RE: Far West Texas project

# ERCOT Independent Review of the AEPSC and Oncor Far West Texas Project

ERCOT REGIONAL PLANNING GROUP PROJECT SUBMITTAL FOR REVIEW

Figure 2.2: Proposed Far West Texas Project

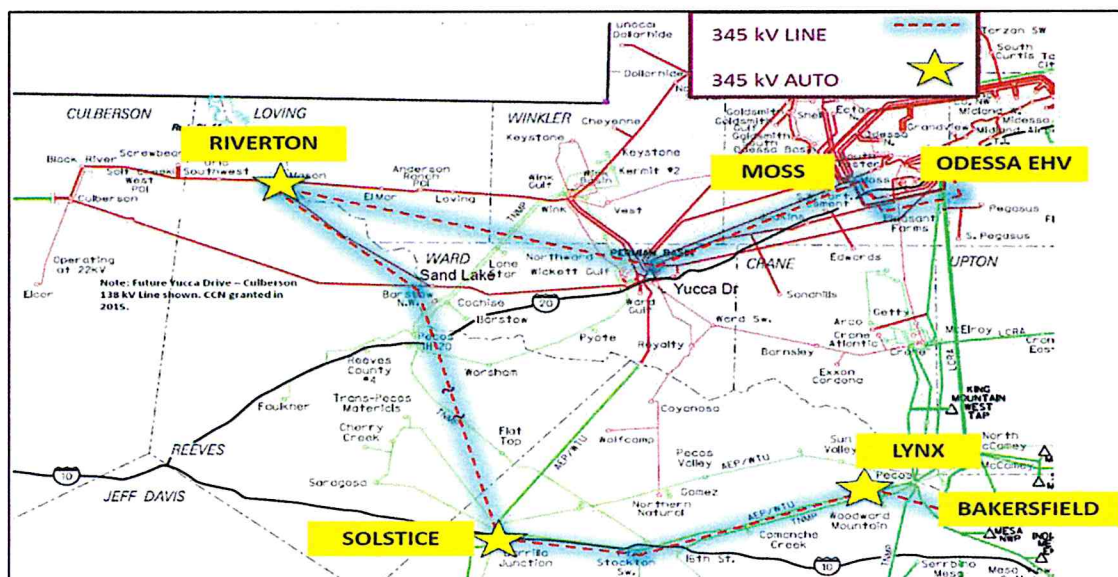
On April 20, 2016, Oncor and AEPSC submitted the Far West Texas Project (FWTP) to the Regional Planning Group (RPG) to address the transmission needs both in the Barilla Junction area and the Wink – Culberson – Yucca Drive 138 kV transmission loop (“Culberson loop”). This project was estimated to cost \$423 million and was classified as a Tier 1 project. Figure 2.2 shows the proposed FWTP. The major components of this project proposal were:

Based on the FWTP proposal, ERCOT completed this independent review to determine the system needs in the Barilla Junction and Culberson loop areas and address those needs in a cost-effective manner while providing the flexibility to meet potential load and generating capacity growth in this region.

Figure 4.1: Study Case Thermal Violations in Study area

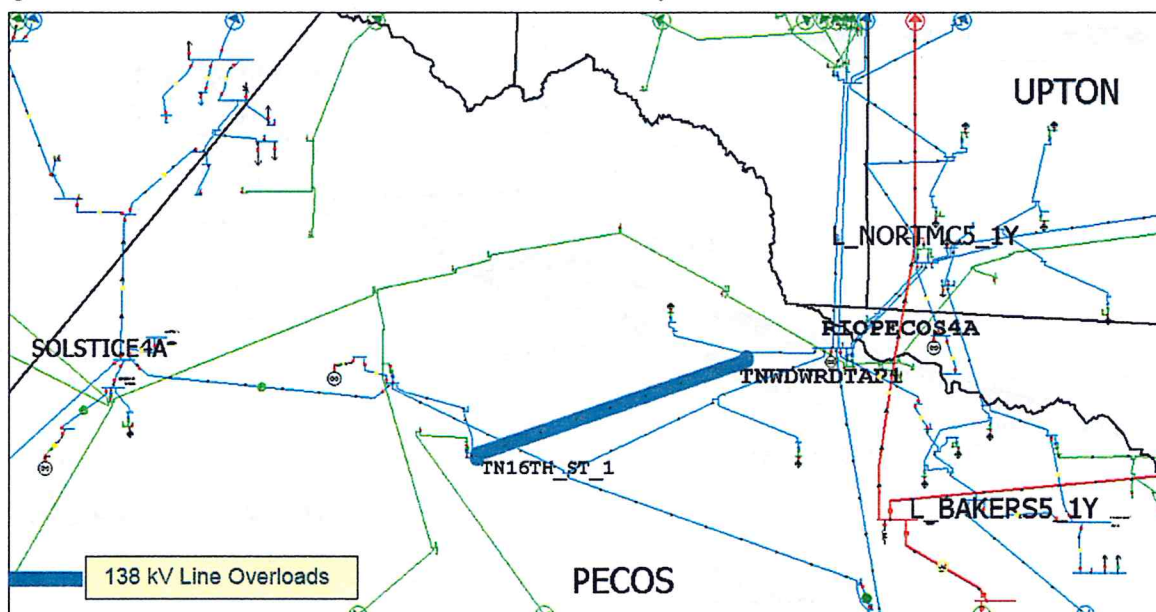
Figure 4.1 shows the thermal violations seen in the Study case.

Figure 4.2: Study Case Voltage Violations in Study area

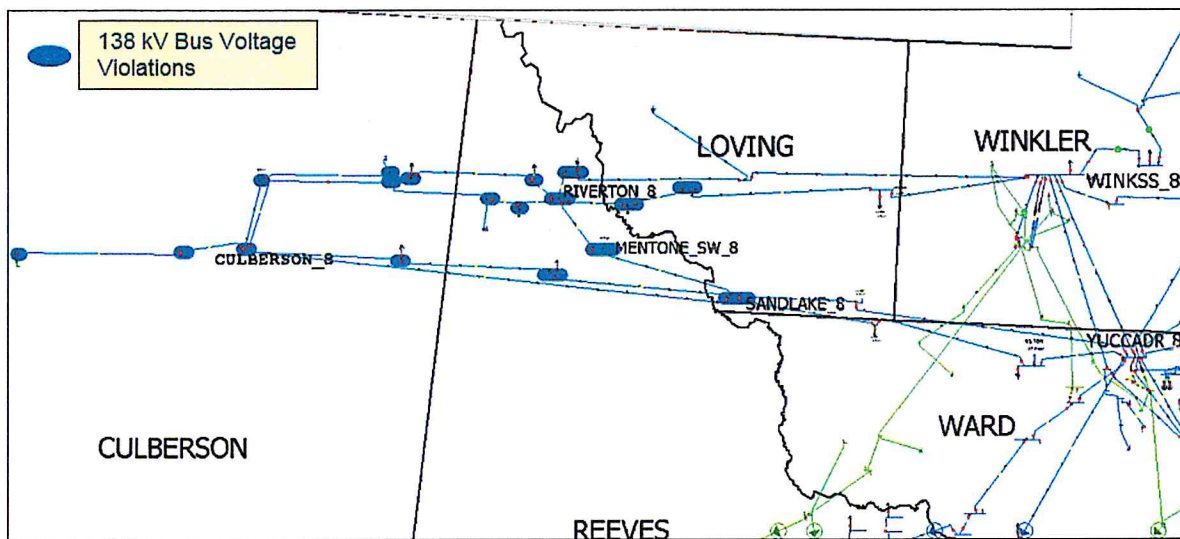
Figure 4.2 shows the voltage violations seen in the Study case.

Figure 4.4: No Solar Case Voltage Violations in Study area

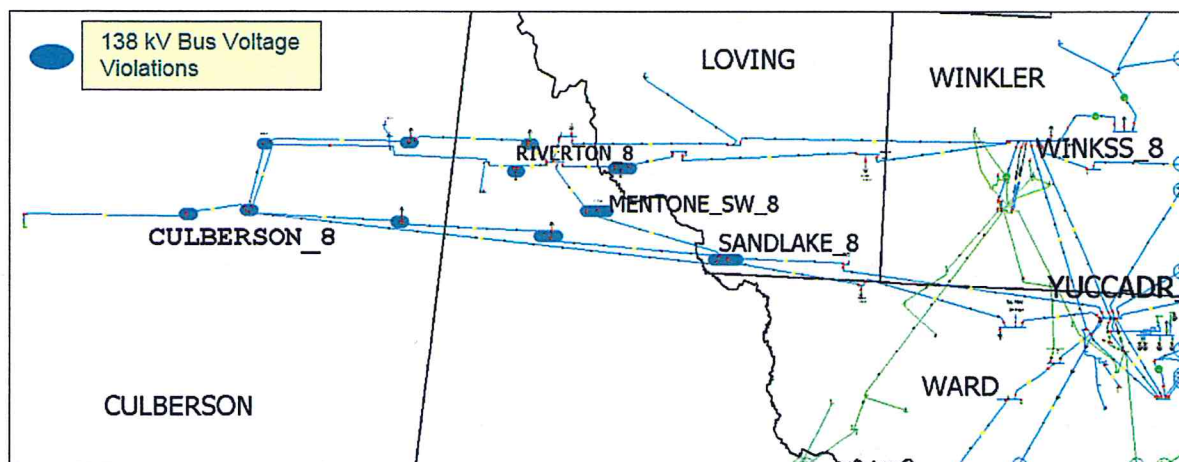
Figure 4.4 shows the voltage violations seen in the No Solar case.

Figure 9.1: Option 2 applied to the Study area

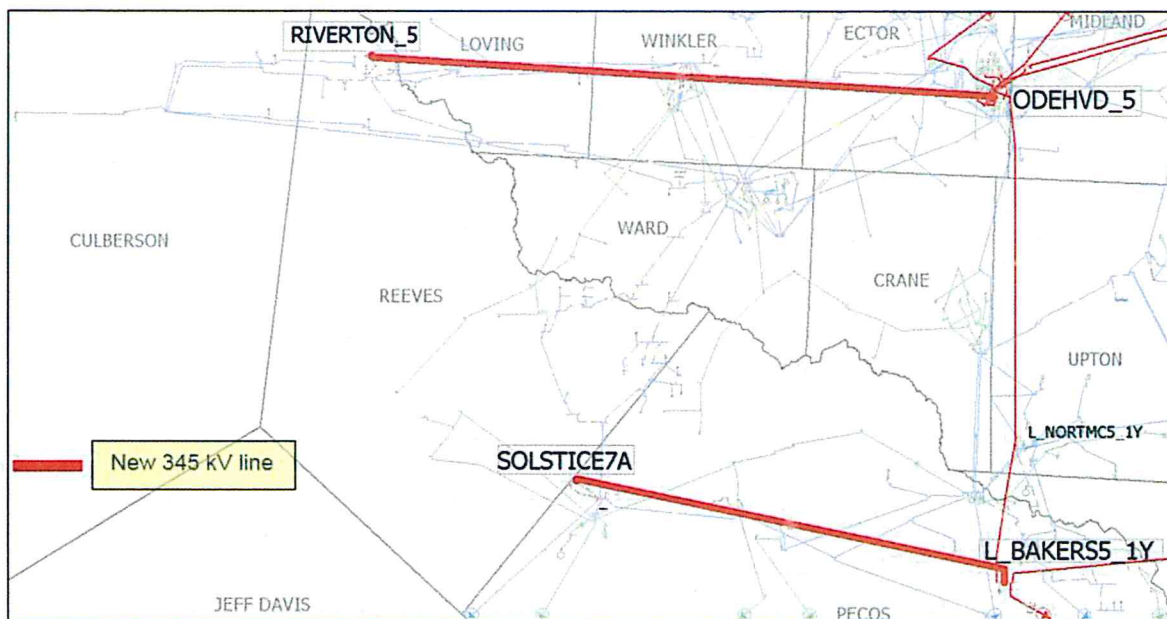
As shown in Table 9.1, a comparison of study results for the short-listed options shows that Option 2 met the system reliability criteria under the Study Case load conditions while deferring more than \$100 million in capital expenditures when compared to the other options. Option 2 also resulted in lower system production costs when compared to Option 1 and was expected to provide an adequate voltage stability margin.

Figure 9.1 shows Option 2 applied to the study area.

**Figure 2.3: Proposed Far West Texas Project 2**

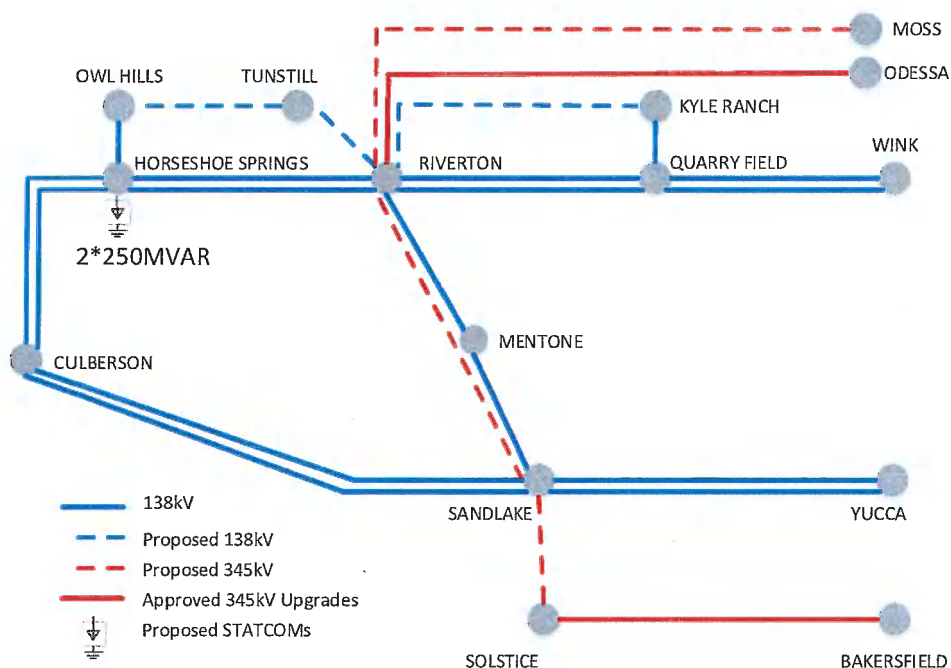
In February, 2018, Oncor submitted the Far West Texas Project 2 (FWTP2) to address reliability requirements and ensure the transmission system in the area is able to meet the projected load. The proposed FWTP2 project was estimated to cost \$194 million and was classified as a Tier 1 project. At the time the FWTP2 project was proposed, the Culberson Loop area load, again based on contractually confirmed load requests, was projected to serve 775 MW by 2019 and 1013 MW by 2022. Figure 2.3 shows the proposed FWTP2. The major components of the FWTP2 project proposal include:

As of April, 2018, Oncor has updated the contractually confirmed Culberson area load to be 880 MW by summer 2019 and 1013 MW by 2022. Additional load requests could potentially push the load to more than 1300 MW in the Culberson Loop.

Figure 9.1: Option 3

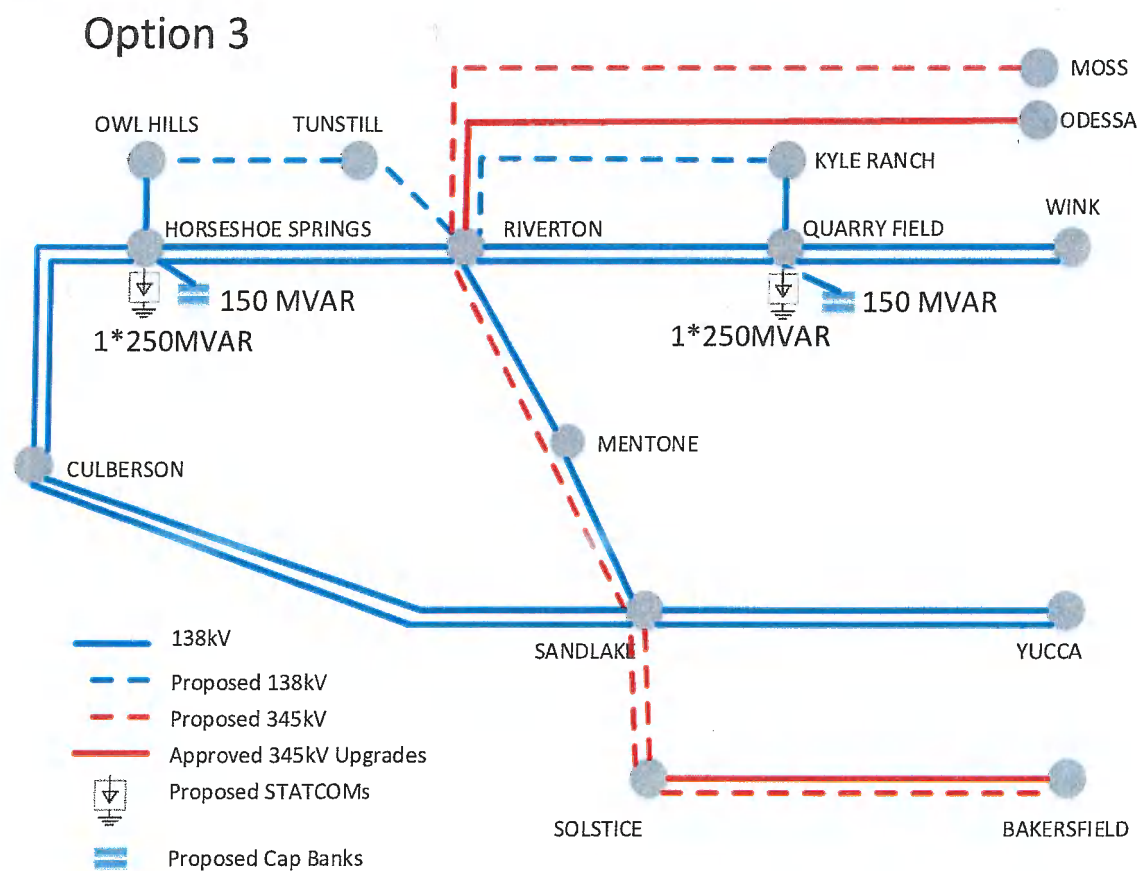
As shown in Table 9.1, a comparison of study results for the three options shows that Option 3, shown in Figure 9.1, met the system reliability criteria under the studied load conditions while providing better load serving capability to accommodate both the near-term and potential future load needs in the Culberson Loop area.

Figure 9.1: Option 3

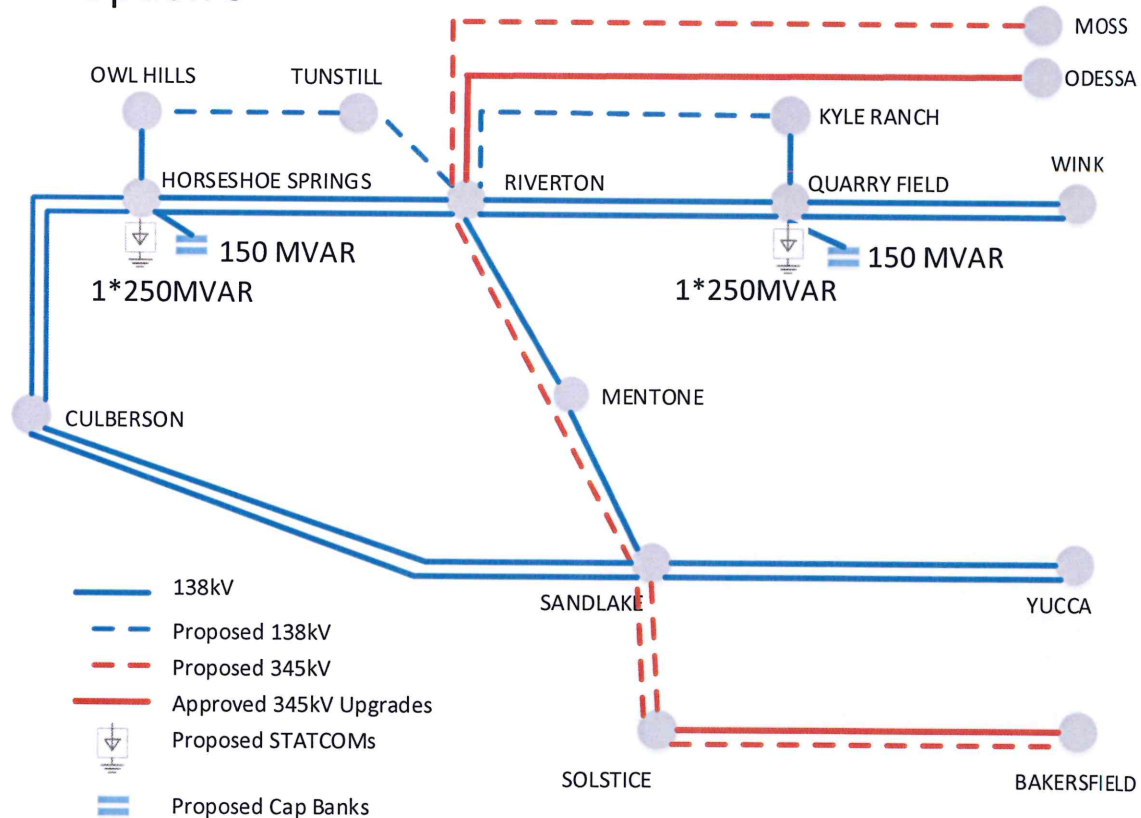
As shown in Table 9.1, a comparison of study results for the three options shows that Option 3, shown in Figure 9.1, met the system reliability criteria under the studied load conditions while providing better load serving capability to accommodate both the near-term and potential future load needs in the Culberson Loop area.
